Docket Item #12  
SUBDIVISION #2005-0008

Planning Commission Meeting  
October 4, 2005

**ISSUE:** Consideration of a request to subdivide the subject property into two lots.

**LOCATION:** 30 Sunset Drive

Plan A

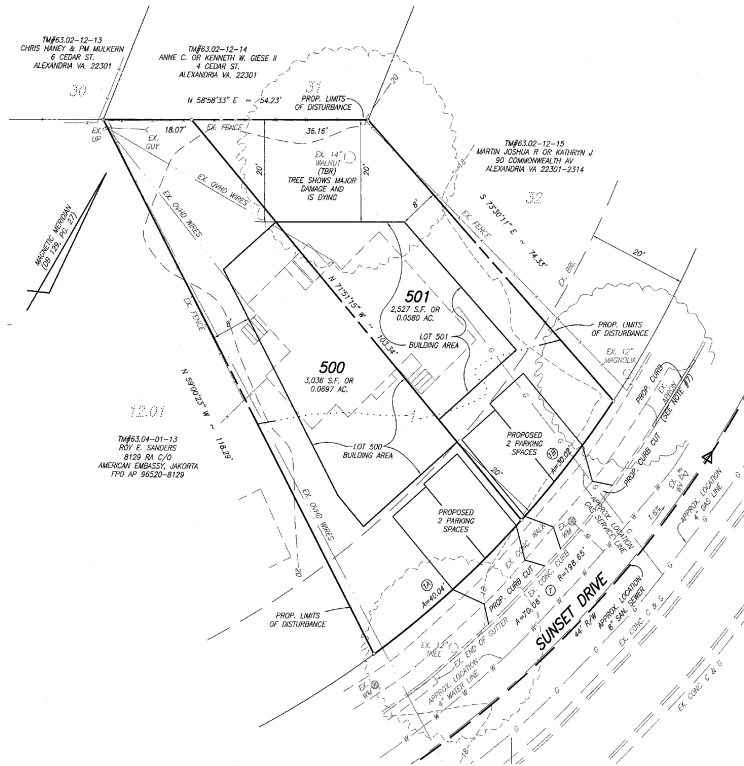
In this case, the subject property is located in the Rosemont Historic District, and access to the property from an alley or interior court is not feasible. At staff's request, the applicant provided a conceptual parking and curb cut scheme as part of the subdivision application (shown here as Plan A). The Director of Transportation and Environmental Services did not support separate driveways for each property as depicted on the plan because the location and configuration of the two driveways on the inside portion of a curve located in close proximity to the intersection of Commonwealth Avenue has poor sight distance which results in a hazardous condition for vehicles backing out onto the street. Staff found that the location and nature of the proposed curb cut and associated parking did not conform with the character and architectural style of the developed blockface, many of which

Section 7-1005 of the Zoning Ordinance requires that no more than 50 percent of any required yard be used for parking of automobiles, including driveways whether paved or unpaved. The schematic parking plan (Plan A) depicts Lot 501 as having more than 50% of the front yard occupied by parking. Under the applicant’s original scenario, a variance would be required. Plan B would not require a variance for front yard parking.

- F-1 T&ES does not support separate driveways for each of the properties as illustrated on the plan because the location and configuration of two driveways on the inside portion of a curve located in close proximity to the intersection of Commonwealth Avenue has poor sight distance which results in a hazardous condition for vehicles backing out onto the street.

Plan B

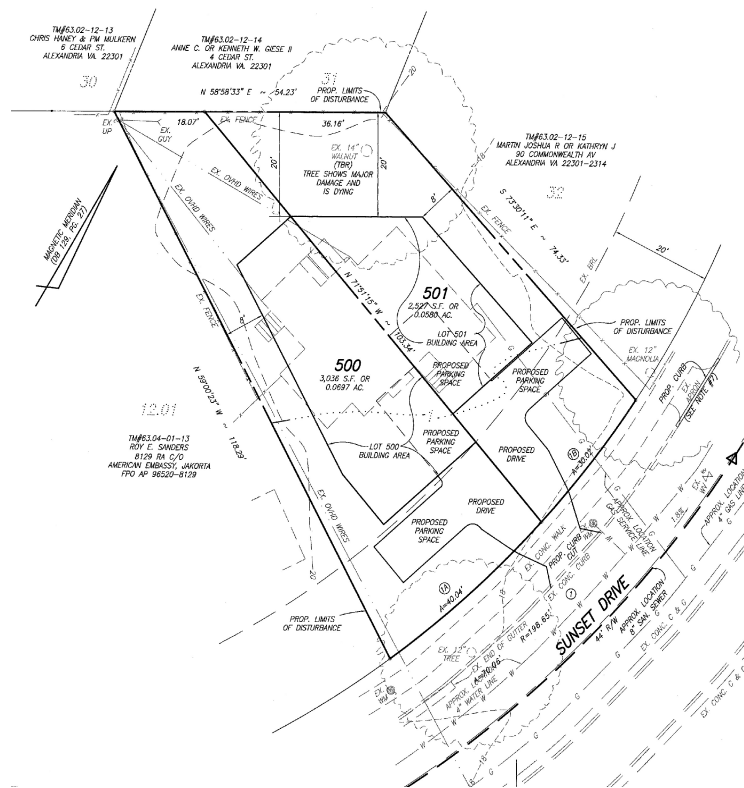
The applicant provided a subsequent scheme (pictured here as Plan B). The proposal includes a single 16-foot wide curb cut for both properties, and front loaded garages and surface parking in the front yard, resulting in a great deal of paving in the front yards of the proposed semi-detached dwellings. It is not clear how vehicles can turn around on-site to avoid backing on to Sunset Drive, a concern raised by T&ES for Plan A. The plan was not provided to staff until the end of the business day on September 23, 2005, the same day staff reports were to be forwarded to the Planning Commission. As a result, other departments have not had an opportunity to review the plan prior to release of this report.

Staff is concerned about the proposed curb cuts and parking configuration as depicted on the applicant's schematic development scenario. The proposed curb cuts and parking plan was found to be unsafe by the Department of Transportation and Environmental Services. As indicated previously, a revised parking and access plan was just recently received. The revised plan results in a large curbcut and extensive paving and parking in the front yard.

5. This subdivision is contingent upon the approval of a parking and access arrangement for the Lots 500 and 501 by the Directors of Planning and Zoning and Transportation and Environmental Services, with the goals of maintaining public safety, and minimizing parking in the front yard. The Directors' determination may include that no parking or reduced parking is appropriate, which would require that the applicant apply for a Special Use Permit for a parking reduction. (P&Z) (T&ES)
6. The applicant shall submit an application for any proposed curbcut for approval by the Directors of Planning and Zoning and Transportation and Environmental Services. (P&Z)
